A585 Windy Harbour to Skippool Improvement Scheme

7.11 Environmental Statement Changes and Corrections Document

May 2019

Rev	Status	Rev. Date	Purpose of revision	Drawn	Check'd	Appr'd
1	SS	MAY19	S8 - DEADLINE 2 SUBMISSION	JN	KB	NH
0	SS	OCT18	S8 - DCO SUBMISSION	JN	KB	NH

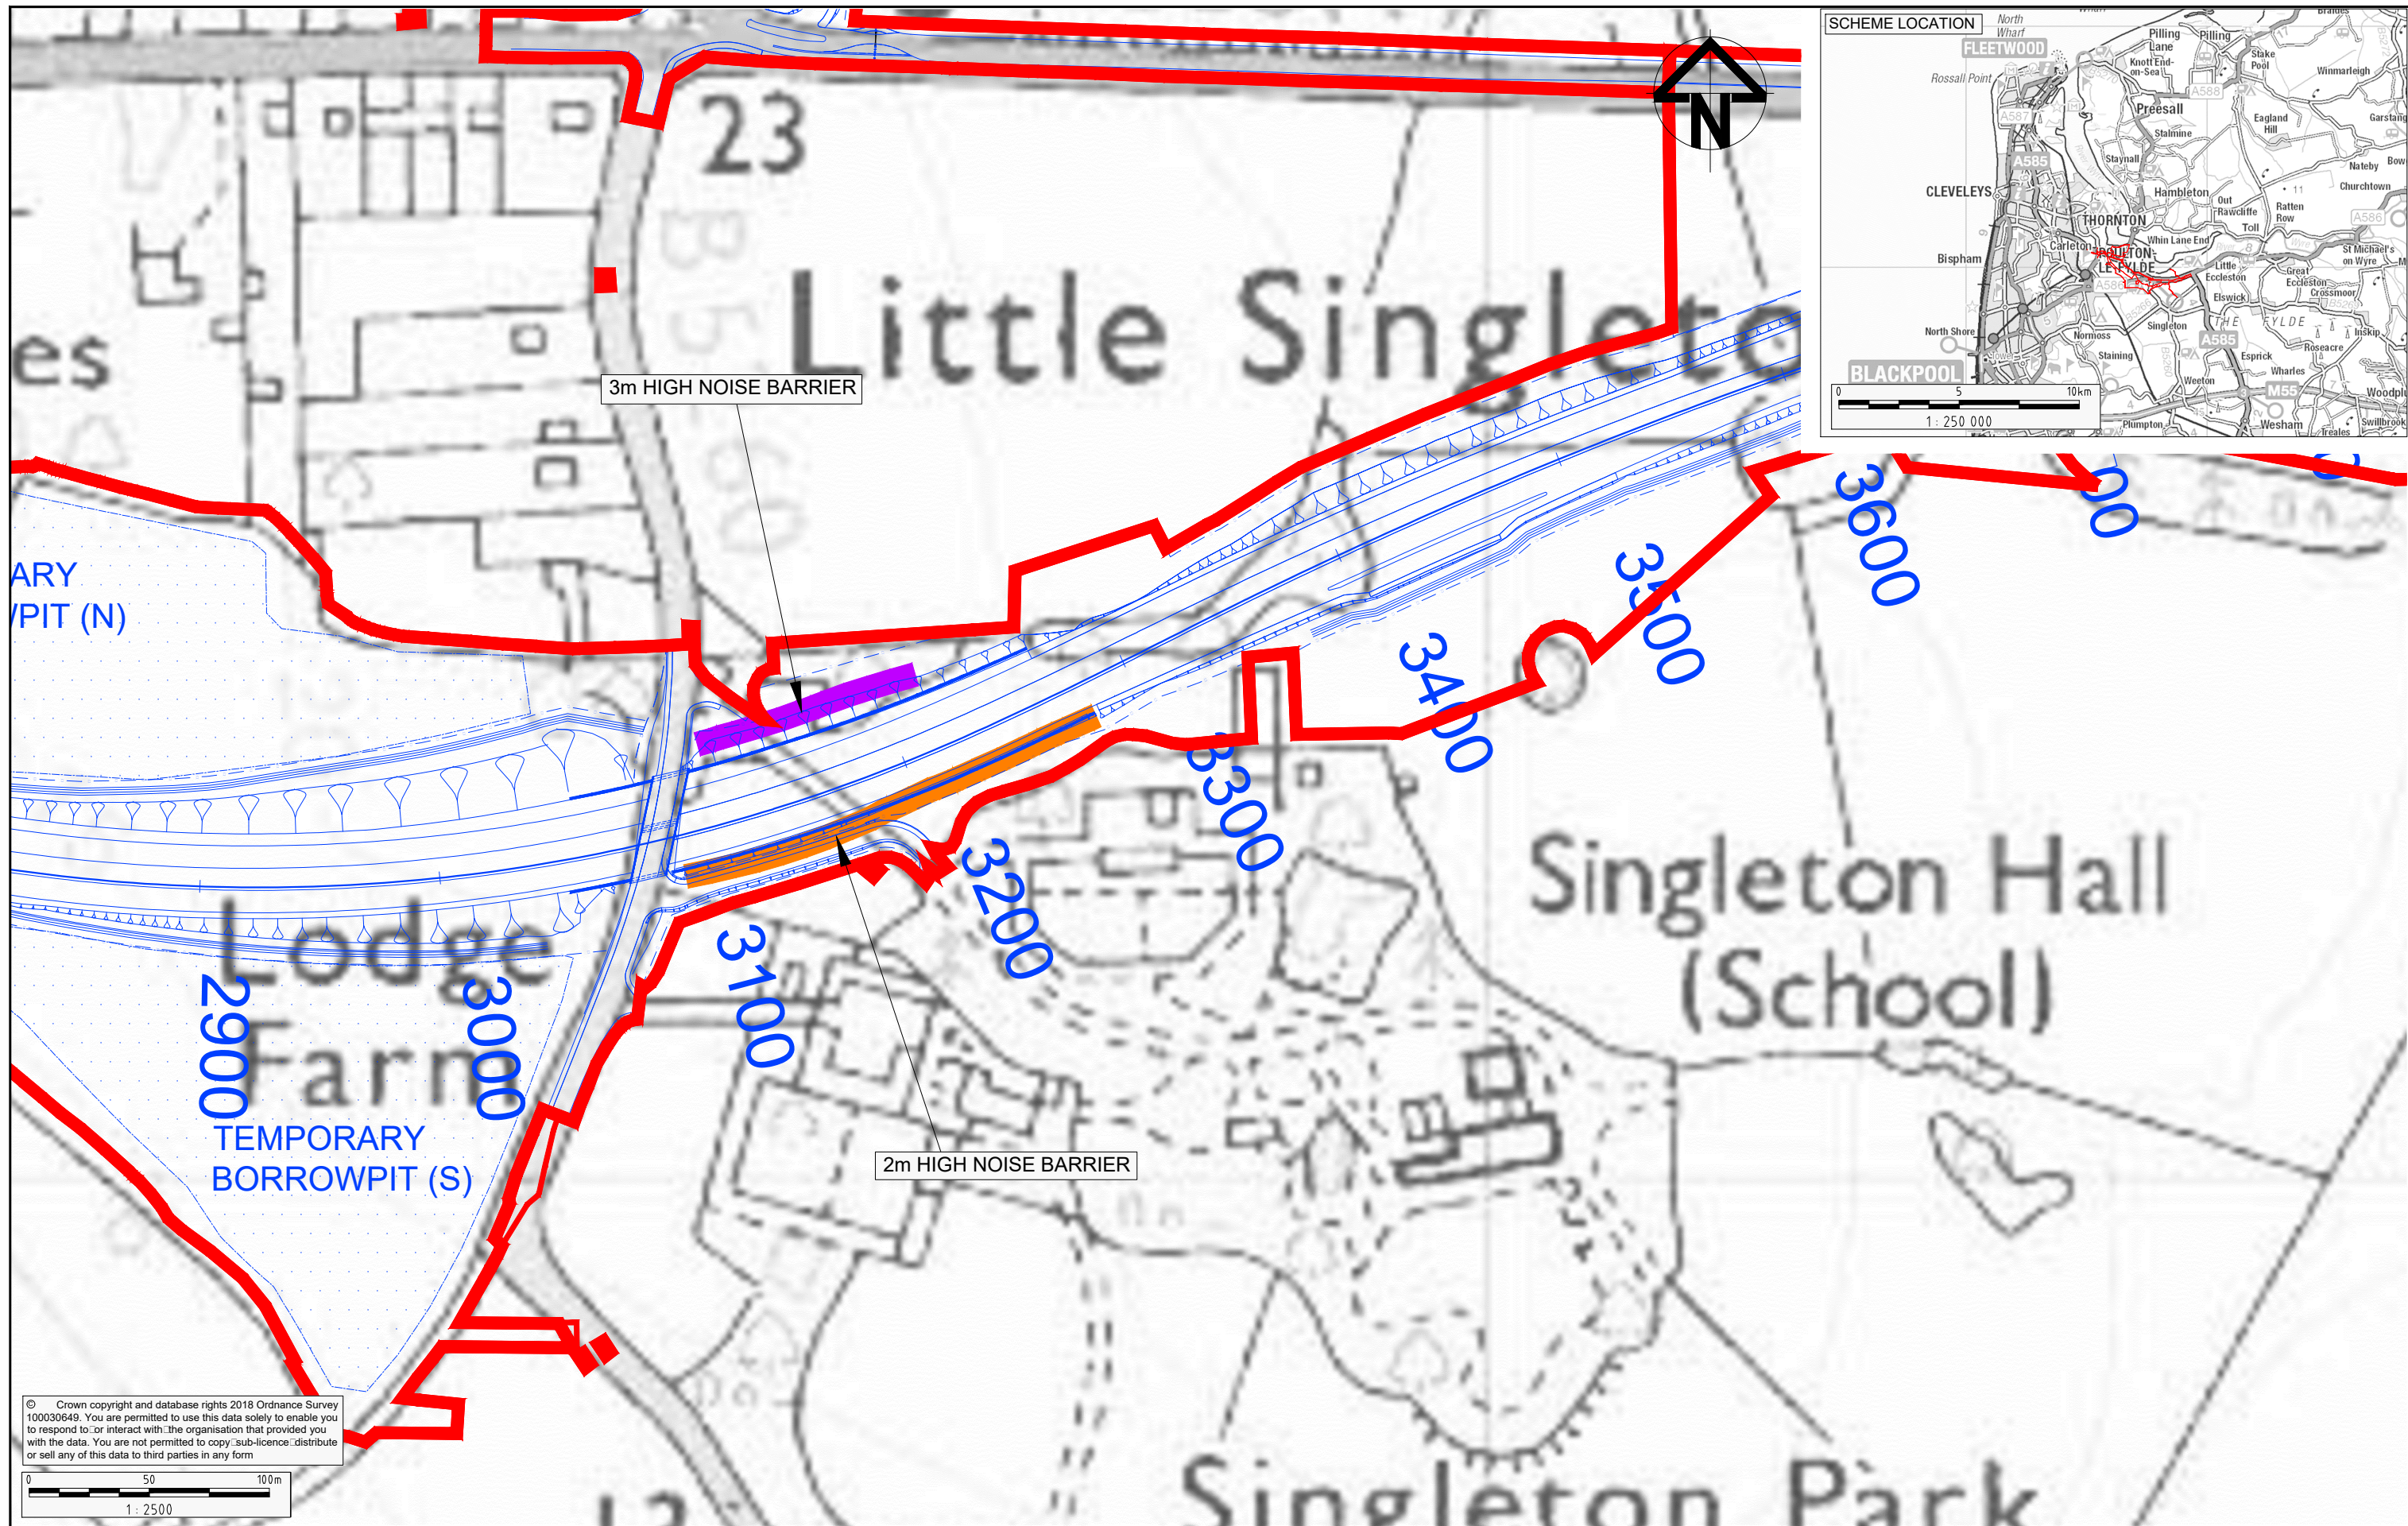
6.11	ES Chapter 11: Noise and Vibration	Update to Figure 11.4: Noise and Vibration – Noise Mitigation within the Study Area presented at Appendix D to show heights and locations of earth mounds and acoustic fencing at a larger scale.	Requested by the Inspector within the first round of written questions (document reference TR010035/APP/7.10).

Client
Project A585 WINDY HARBOUR TO SKIPPOOL IMPROVEMENT SCHEME
Drawing Title ENVIRONMENTAL STATEMENT REGULATION 5(2)(a) ROAD DRAINAGE AND WATER ENVIRONMENT: AqIFERS

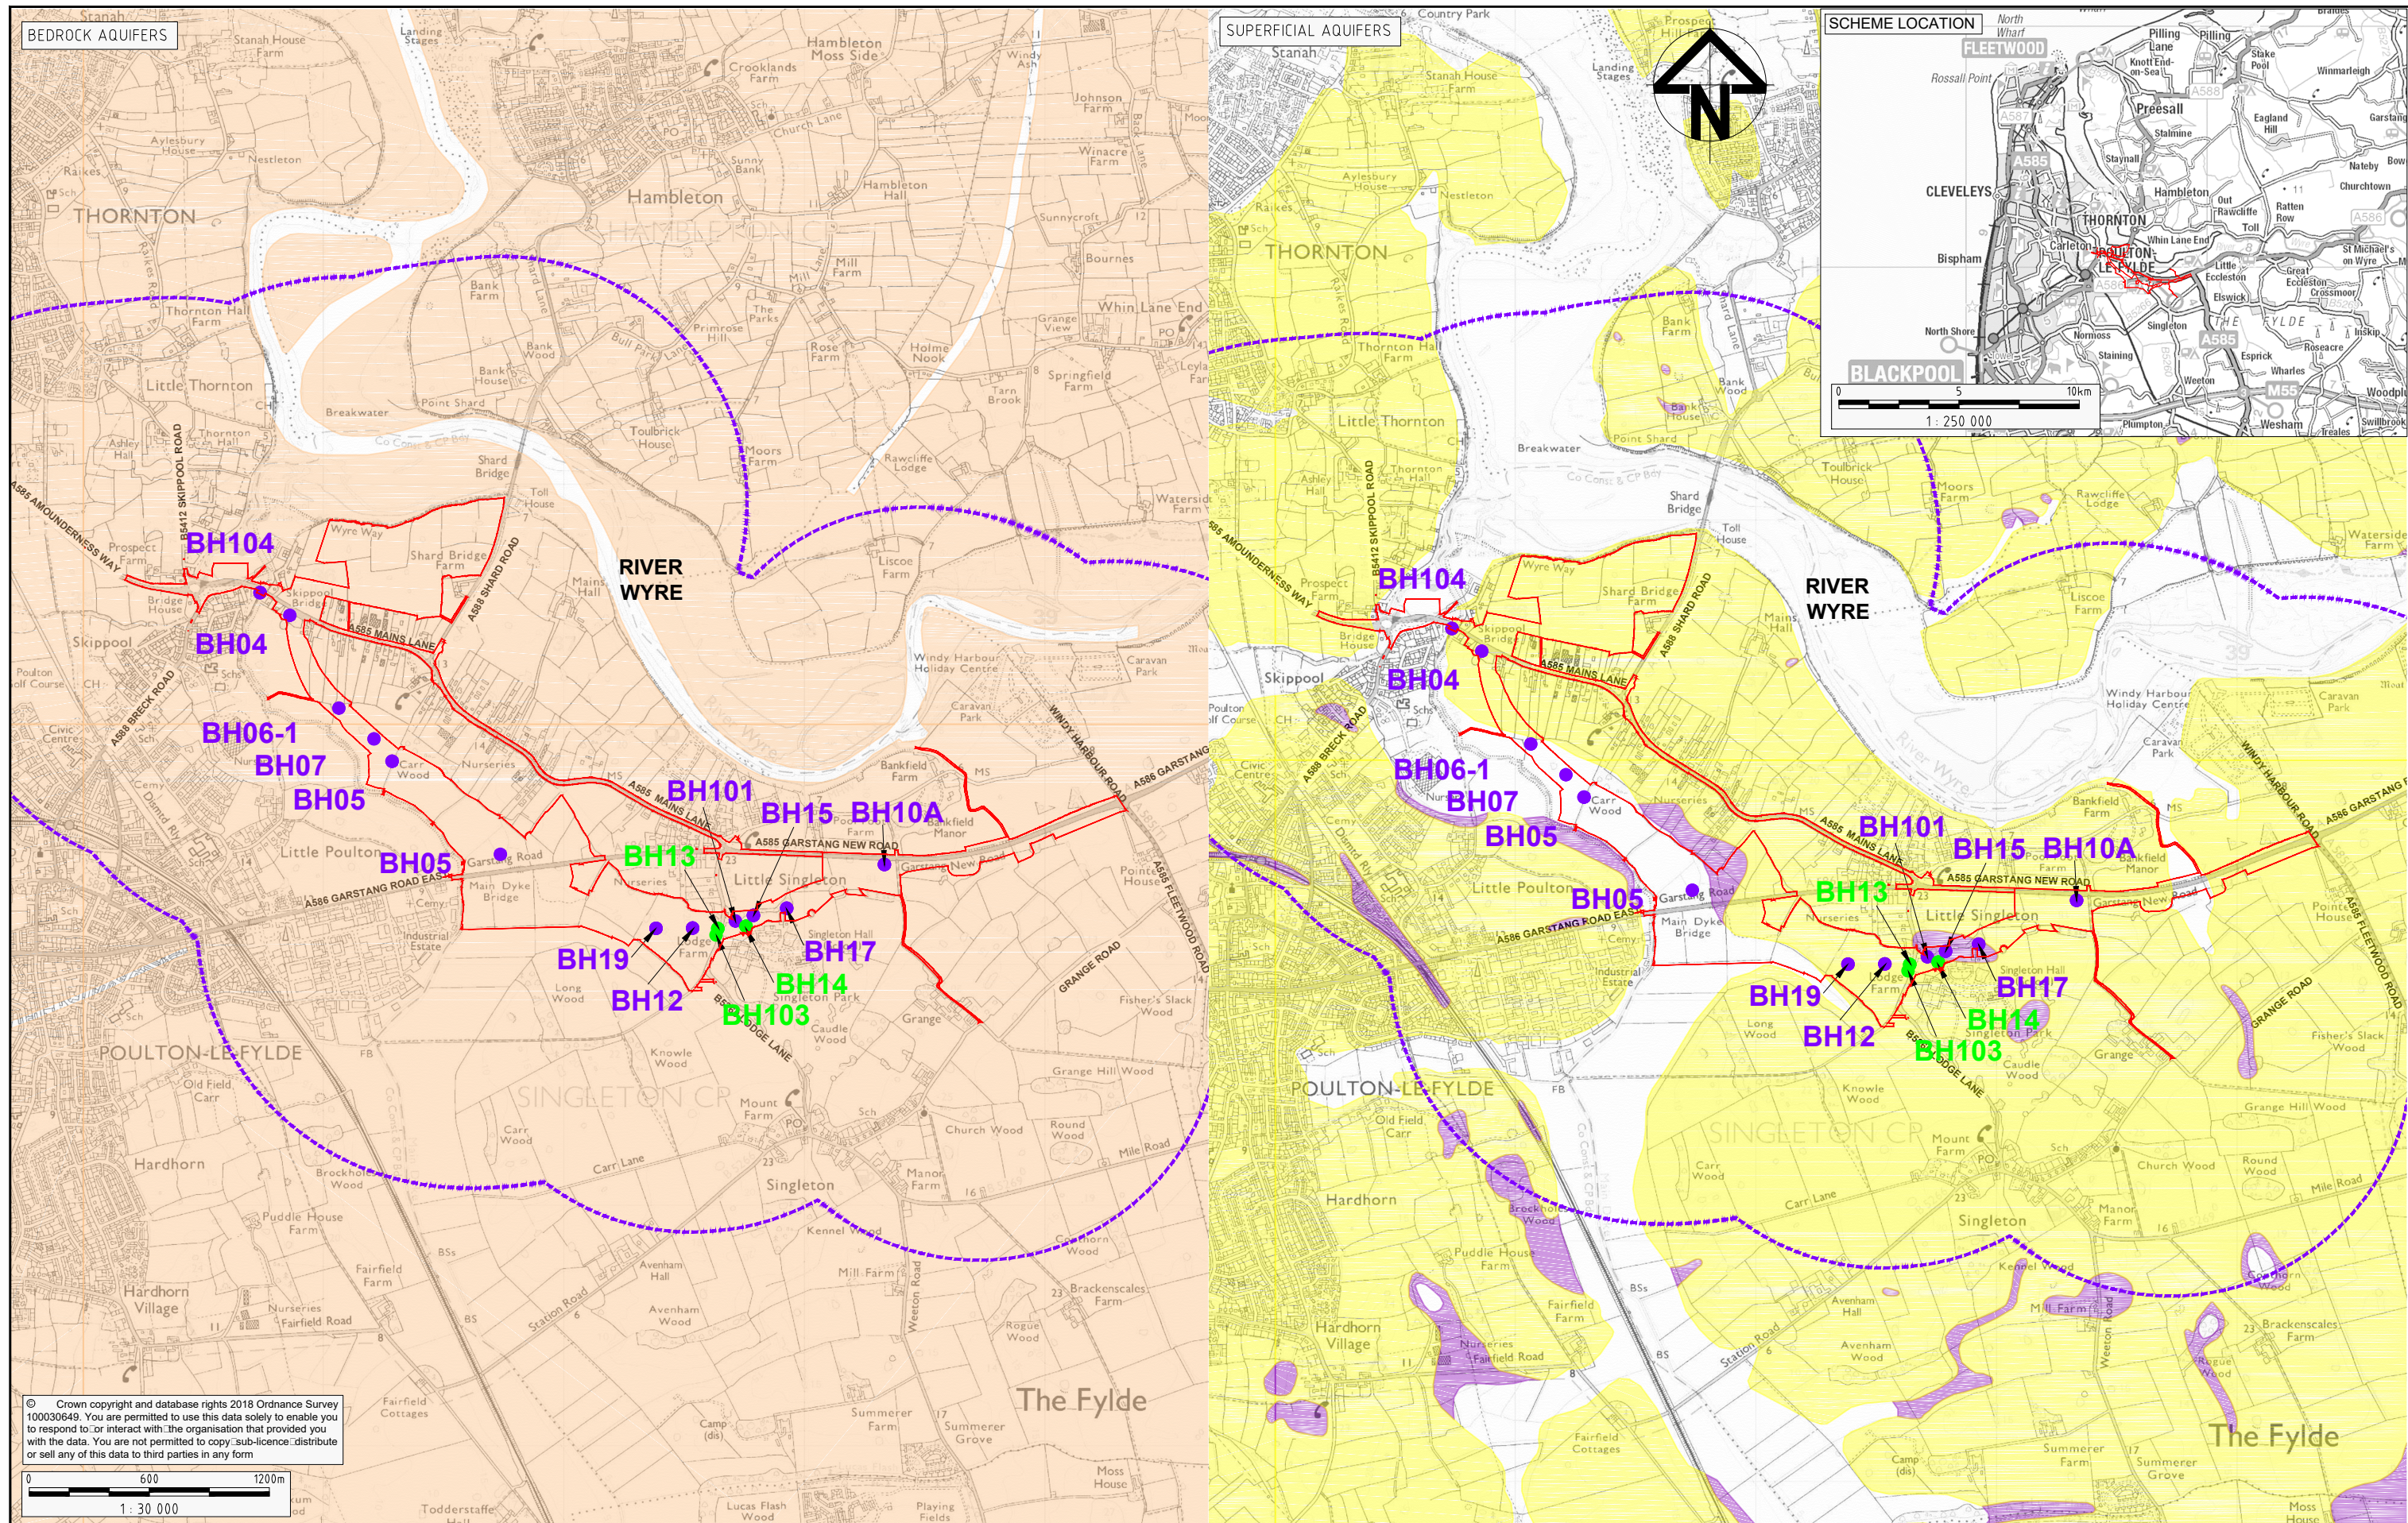
6.12	ES Chapter 12: Road Drainage and the Water Environment	Updated Figure 12.2: Road Drainage and The Water Environment – Aquifers provided at Appendix F to show locations of manual and automated readings for groundwater investigations.	Requested by the Inspector within the first round of written questions (document reference TR010035/APP/7.10).
